SUBJ: Distribution of EPA "NOD/ROD" Notice and "NOD/Availability of ROD" Notice to State of Florida; Tampa Electric Company; EPA EIS for Tampa Electric Company Polk Power Station

PUBLIC NOTICE OF NPDES PERMIT DETERMINATION (NOD)
AND
EIS RECORD OF DECISION (ROD)

Facility Name: Tampa Electric Company, Polk Power Station
Location: Polk County, 9995 SR 37 South, Mulberry, Florida 33860
Permit No.: FL0043869
Permit Effective Date: January 1, 1995
Prior Public Notice No.: 94FL0012; 94FL0016 and 94FL0017
Prior Public Notice Date: February 17, 1994; February 24, 1994
Draft EIS Notice of Availability Date: February 25, 1994
NPDES Permit/EIS Public Hearing Date: March 31, 1994
Final EIS Notice of Availability Date: June 10, 1994
EIS Record of Decision Effective Date: July 14, 1994

TO: Power Plant Siting Review Committee
FROM: Buck Oven *9/13/94*
DATE: September 19, 1994
SUBJECT: Modification of TECO Polk Power Station
PA 92-32A

FIGURE FDEP-6.1.
WATER MASS BALANCE, ANNUAL AVERAGE MAKEUP
(UPDATED 09/01/94)
 Sources: UE&C, 1992. Texaco, 1992. Bechtel, 1994. ECT, 1992.

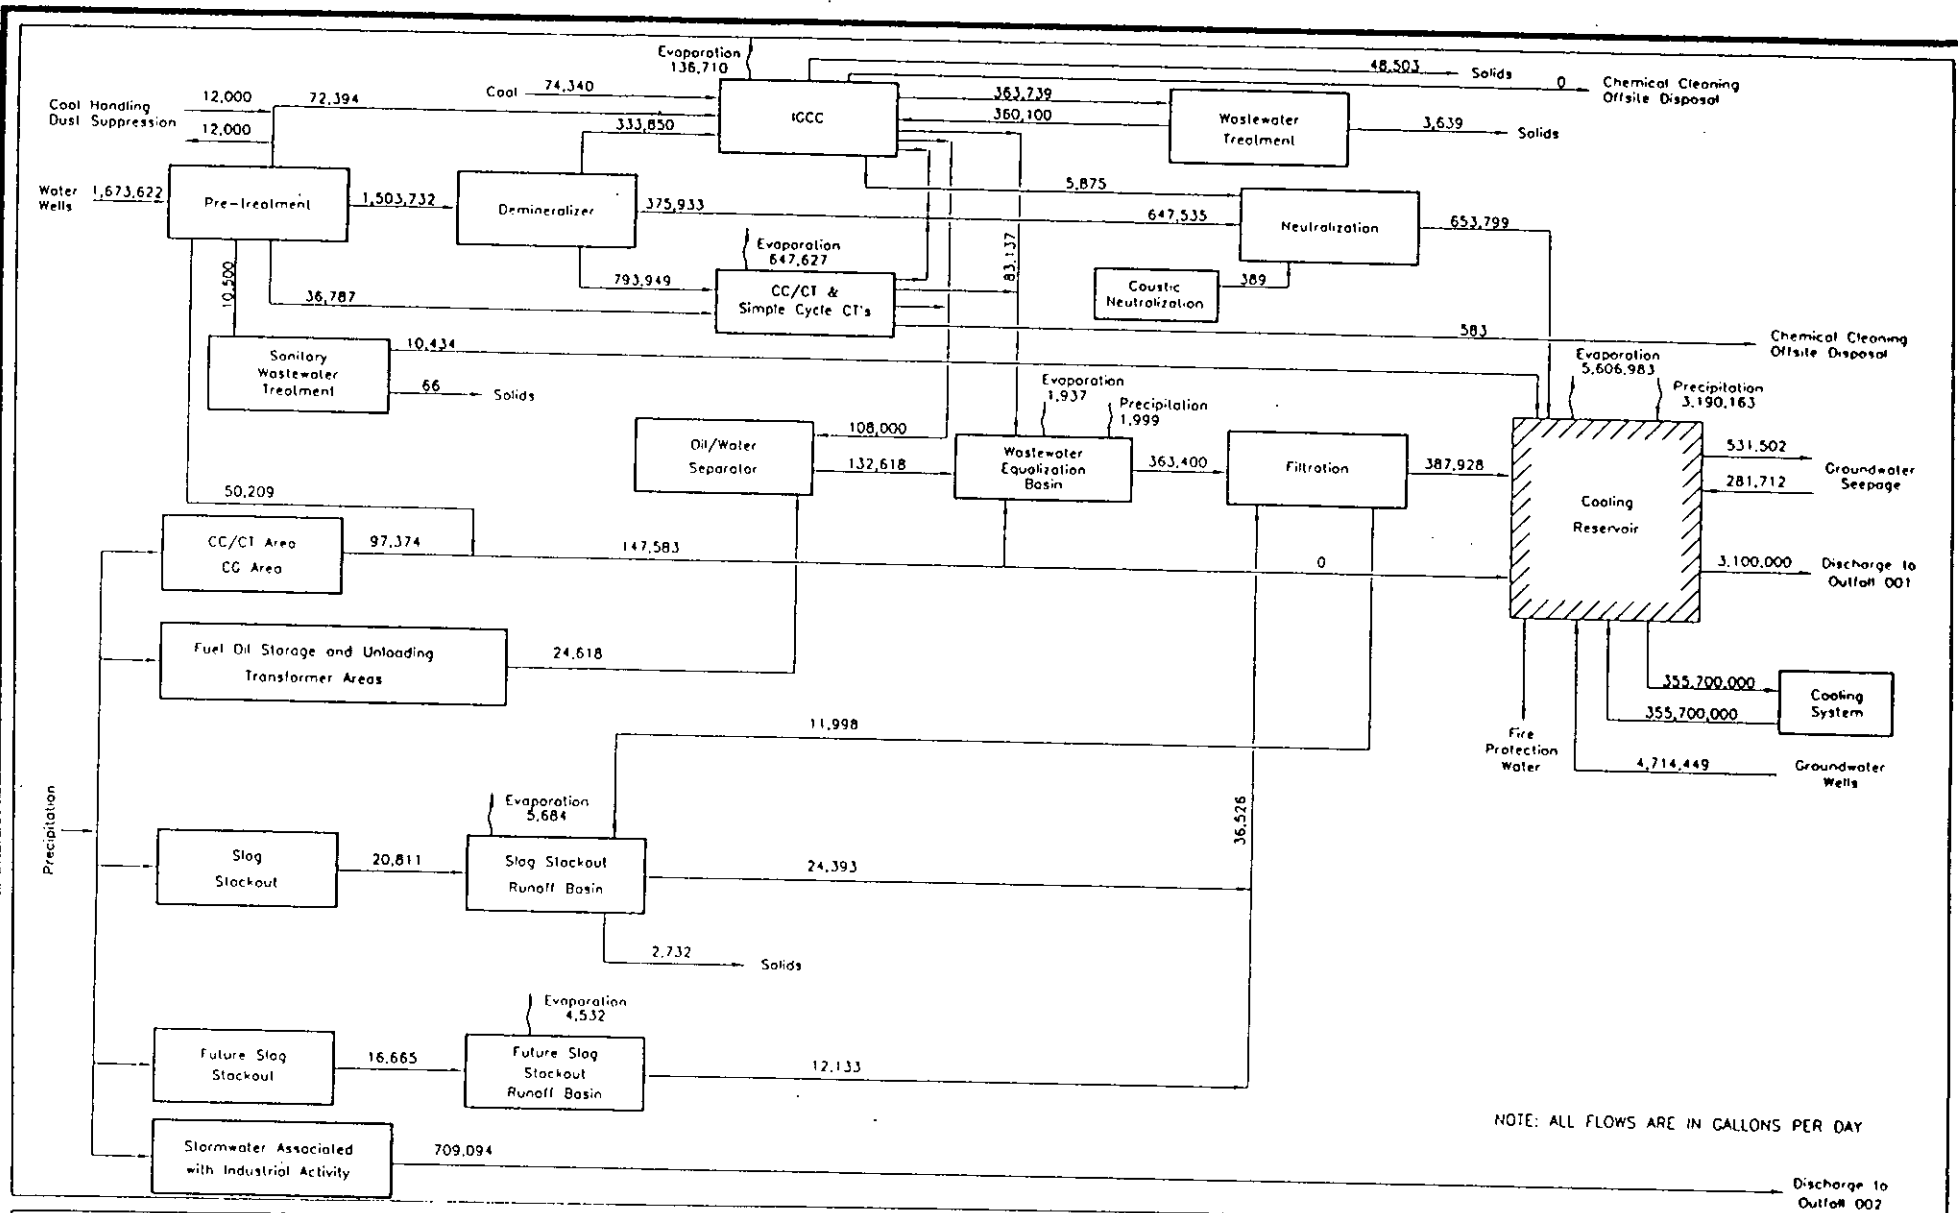
6. We have some concern about the proposal to discharge the sulfuric acid plant wastewater stream to the equalization basin. Condition of Certification XIV. c. requires that combined discharges to the cooling pond fall within the pH range of 6.0 - 9.0. If the discharge from the equalization basin is considered a "combined" FDEP-6

In Tables 2.3-1 and 2.3-2 in the Postcertification Design Updates document, the primary reason for the increases in sulfate concentrations in the equalization/filtration wastewater

FIGURE FDOT-1.A.
PRIMARY TRUCK ROUTE

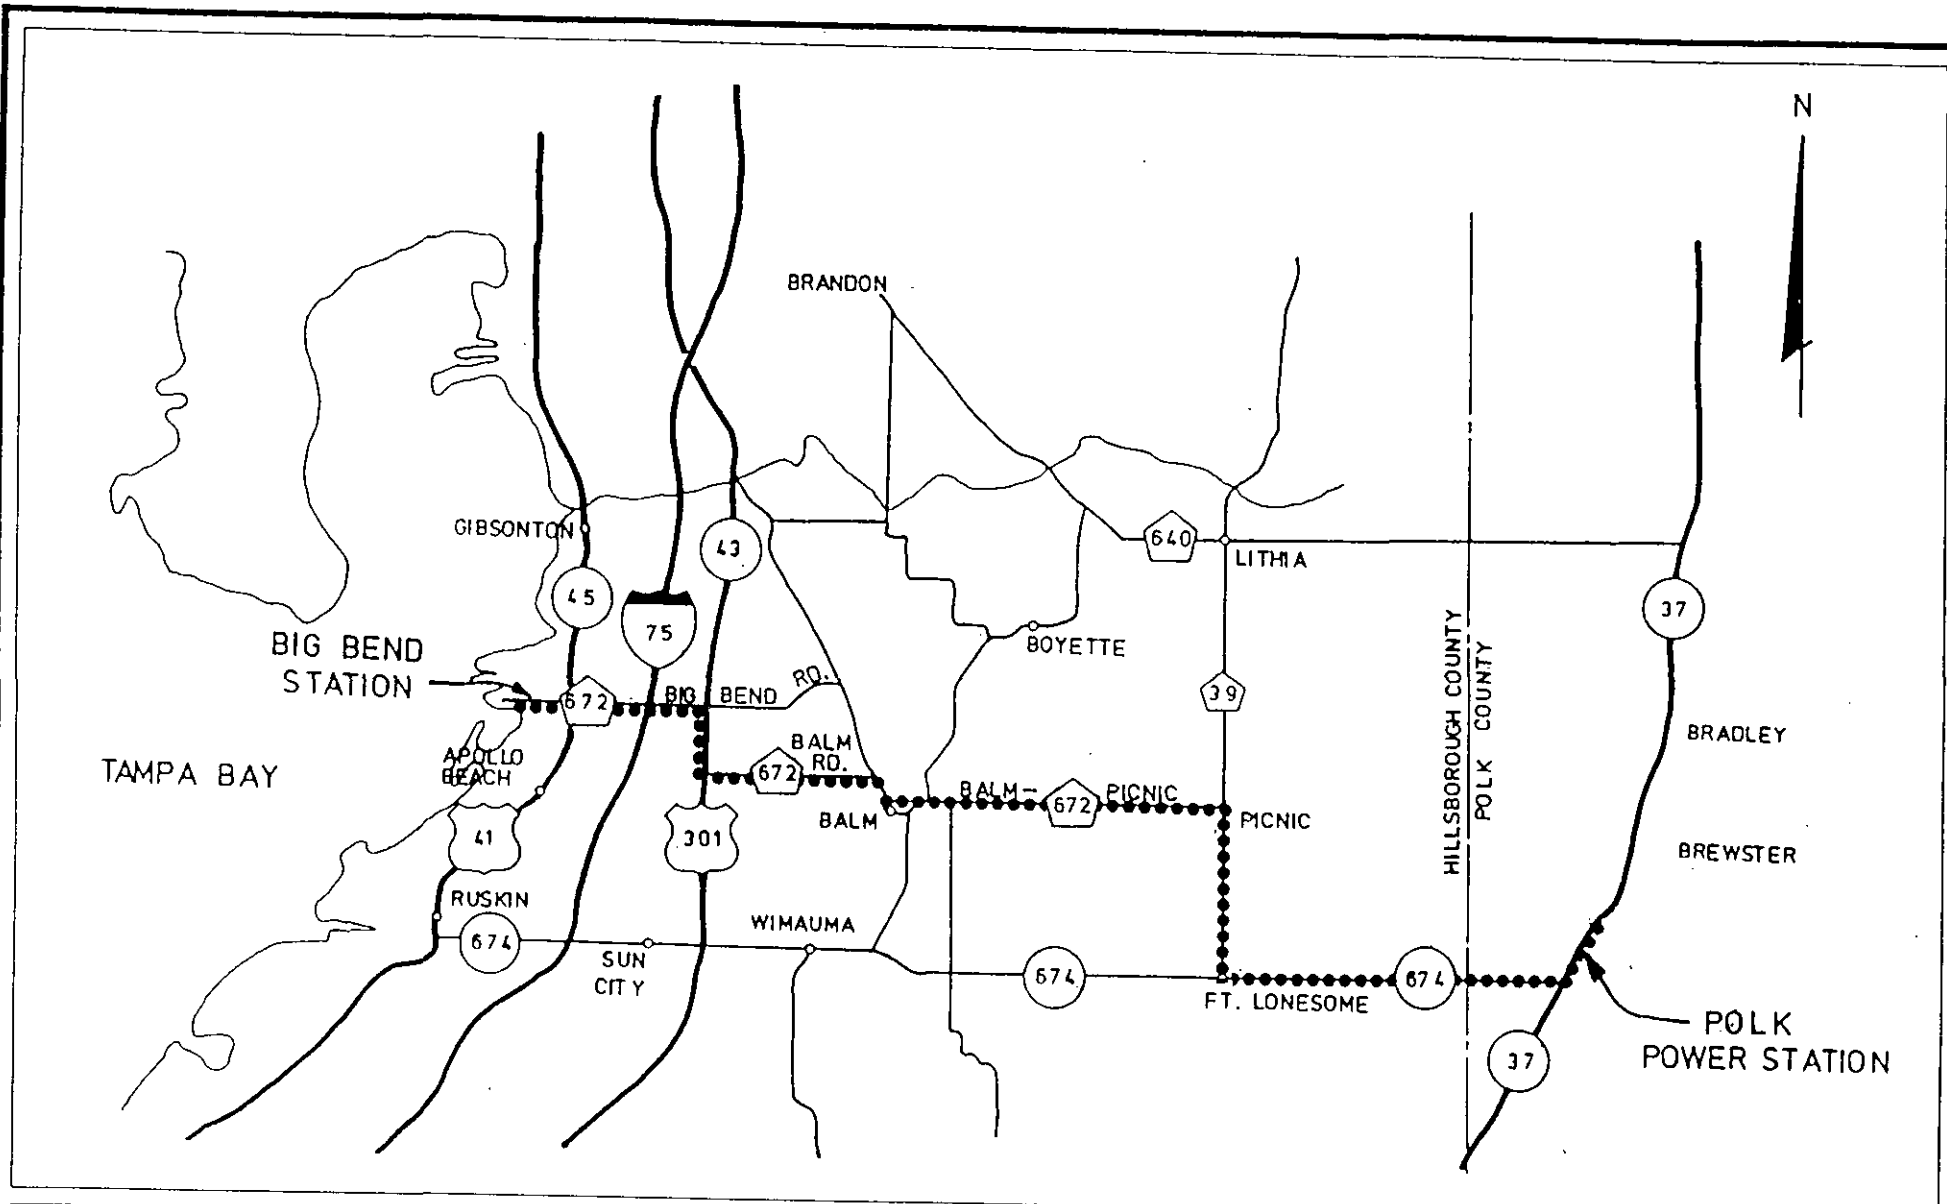
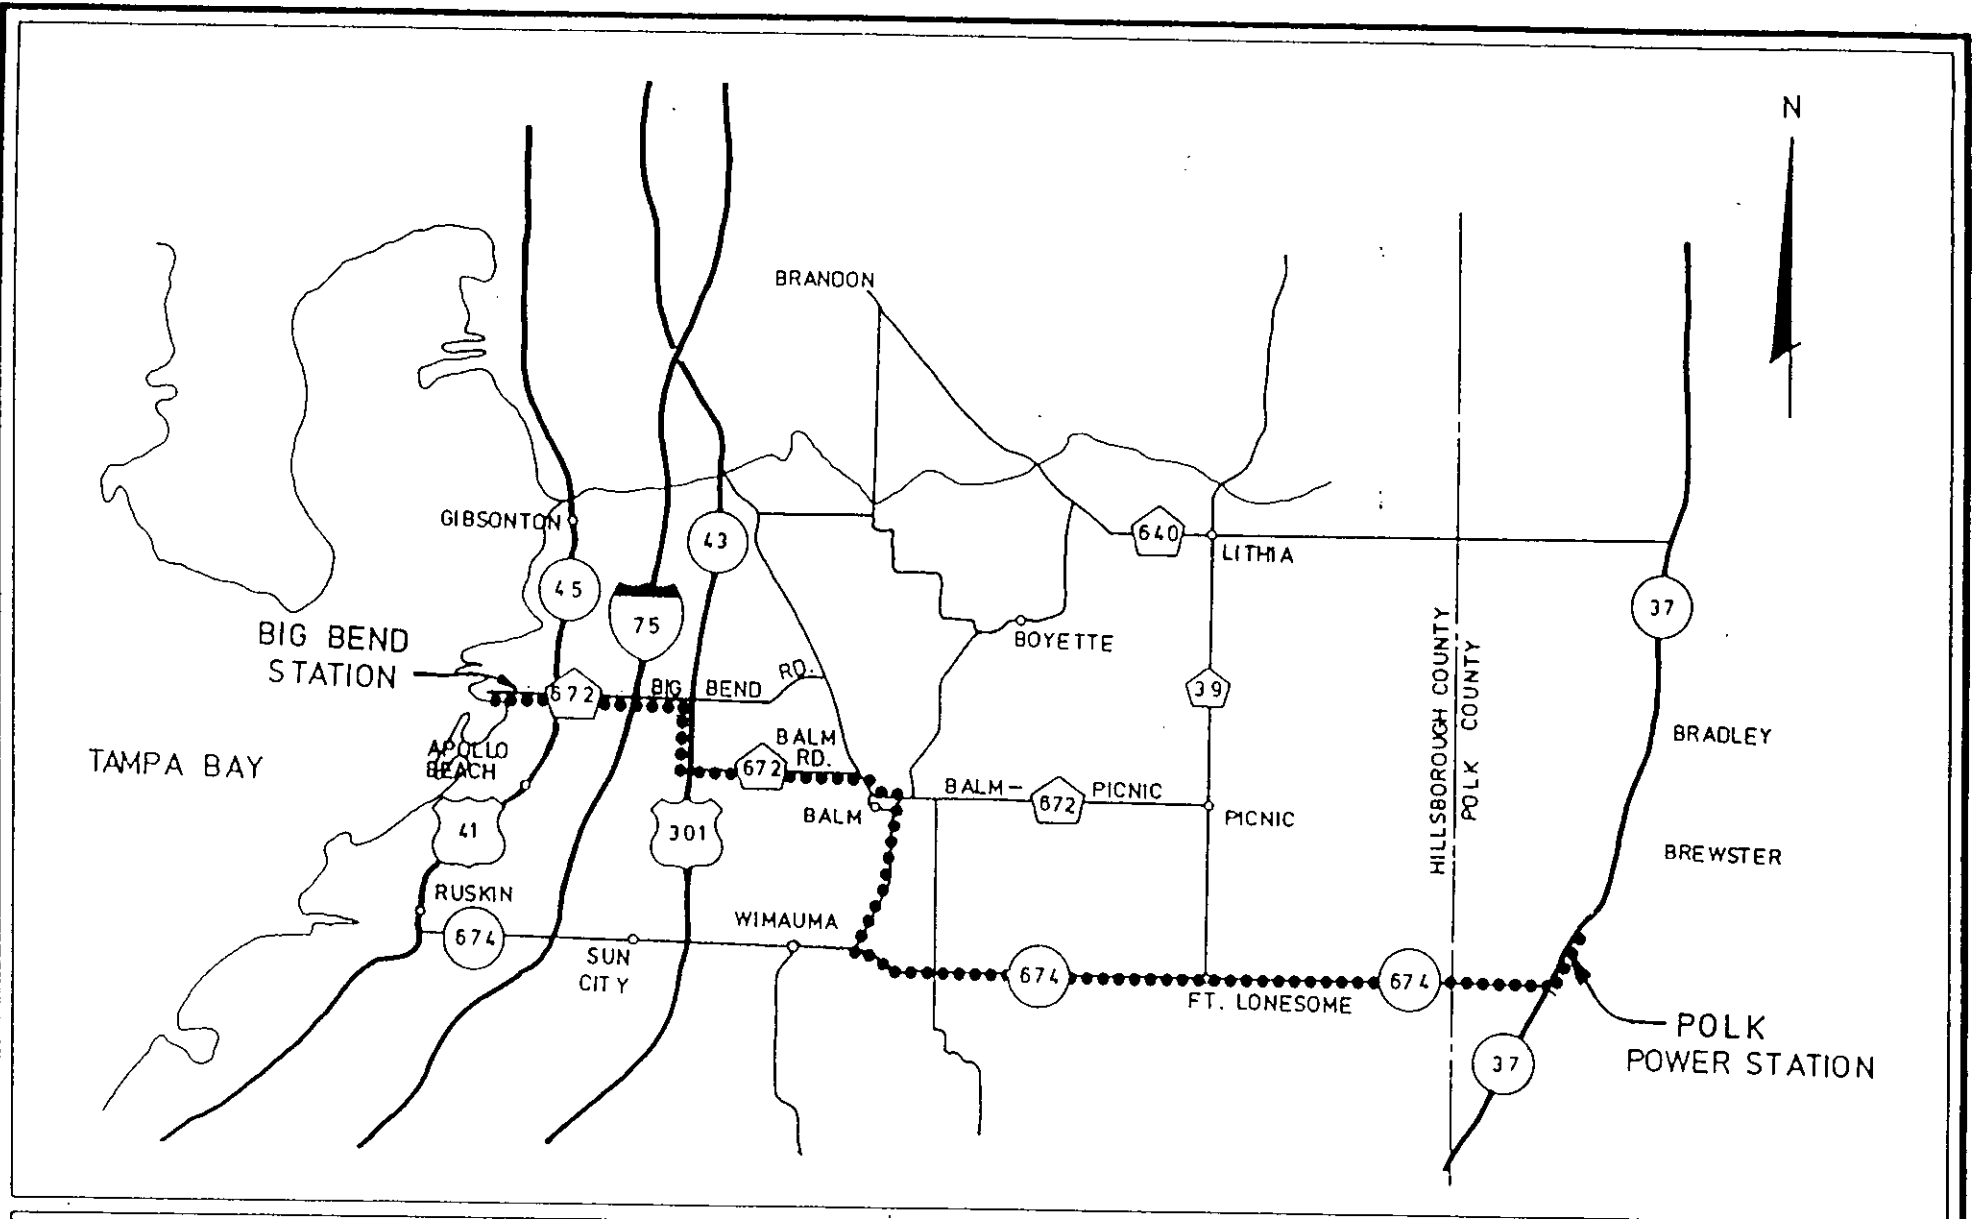
FDOT-2. An analysis on the structural impacts to the haul route, including, but not limited to, State Road 60, State Road 60A, State Road 37 and U.S. 98.

Secondary Route--The secondary route is the same as the primary route except instead of proceeding on Balm Road to CR 39, the trucks will turn right on Balm-Wimauma Road and proceed south to SR 674. The trucks will then turn left on SR 674 and proceed east to SR 37.
